GEARCASE FAILURES - 75 thru 125

This is a revision of Outboard Service Bulletin 96-17. Destroy existing Bulletin 96-17 and insert revised Bulletin 96-17.

1995, 1996 and 1997 Mercury / Mariner 75 thru 125 HP Models, serial number
USA 0G077367 thru 0G589999
BELGIUM 9836633 thru 9973099

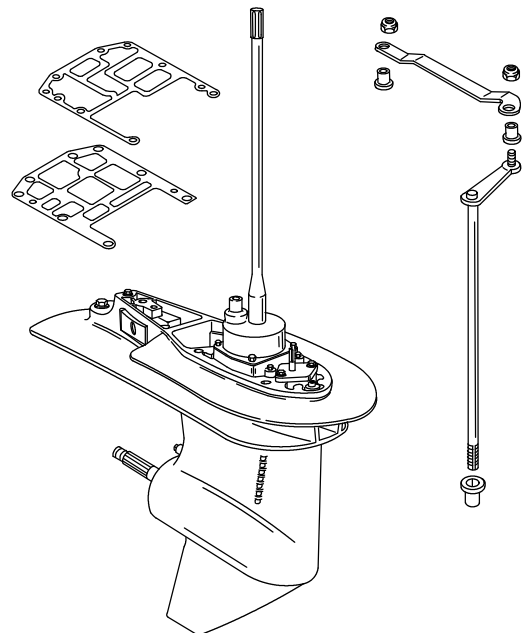
Jumping Out of Gear - If the unit will not stay in gear, the clutch dogs are probably rounded off. Inspect the clutch dogs for rounded edges. Rounded clutch dogs are caused by, but not limited to, improper shift cable adjustment, inadequate shift travel, idle rpm too high, and/or shifting too slow. **Rounded clutch dogs are not covered by warranty.**

A gearcase that has been jumping in and out of gear, may have caused the lower shift shaft pivot hole in the gear housing to elongate and not hold the shift cam in the proper position. Reassembly of that gear hous-

ing should NOT be attempted because the identical failure will be repeated in a short period of time. A visual inspection of the lower part of the lower shift shaft pivot hole in the gear housing is almost impossible. **Failure of a reassembled gear housing with an elongated lower shift shaft pivot hole will not be covered under warranty.**

Shift Cable Installation

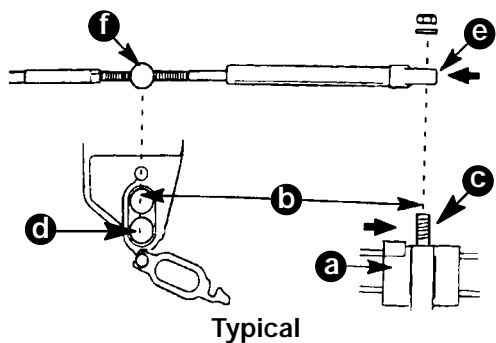
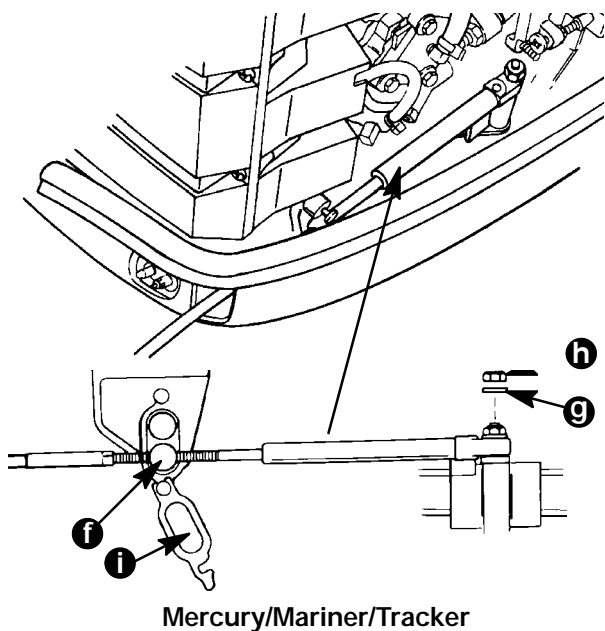
Follow the latest throttle and shift cable adjustment recommendations to ensure gearcase durability.

1. Position the remote control and outboard into neutral.
2. Slide shift actuator (a) toward the rear of engine (reverse gear) until resistance is felt. Measure distance (b) between mounting stud (c) and barrel retainer (d).
3. Push the cable end (e) in (towards cable barrel) until resistance is felt. Adjust the cable barrel (f) to attain distance (b).

4. Place cable barrel (f) into retainer and close latch (i). Fasten the cable end to mounting stud with nylon washer (g) and locknut (h). Tighten locknut against the nylon washer, then back-off the locknut 1/4 turn.

Gear Housing Assembly Identification

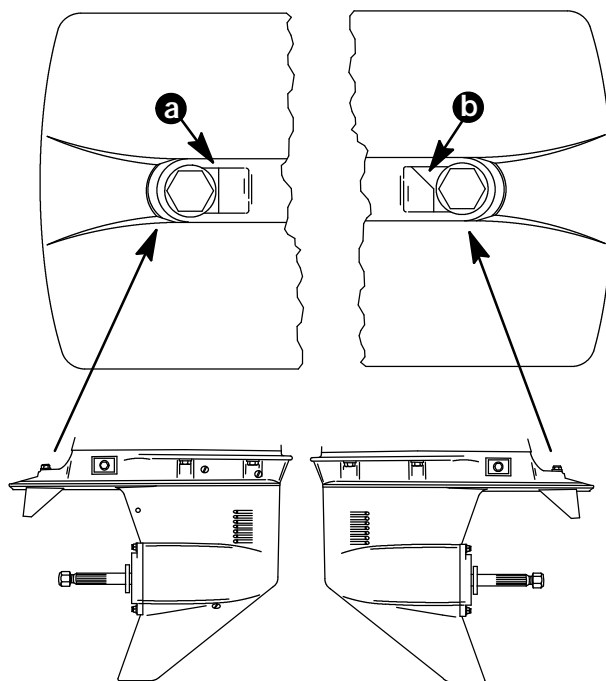
Identify gear case design to ensure correct components are being installed. Design I - "3 Jaw Reverse Clutch" (a) gear case identified with straight machined edge for trim tab screw mounting surface. Design II - "6 Jaw Reverse Clutch" (b) gear case identified with angled machined edge for trim tab screw mounting surface.

After the "6-Jaw Reverse Clutch" gear housing and updated Shift Shaft have been installed replacement parts **MUST** be ordered from the "6-Jaw" section of a 1998 model year and newer parts list. "3-Jaw" and "6-Jaw" reverse clutch parts are **NOT** interchangeable.
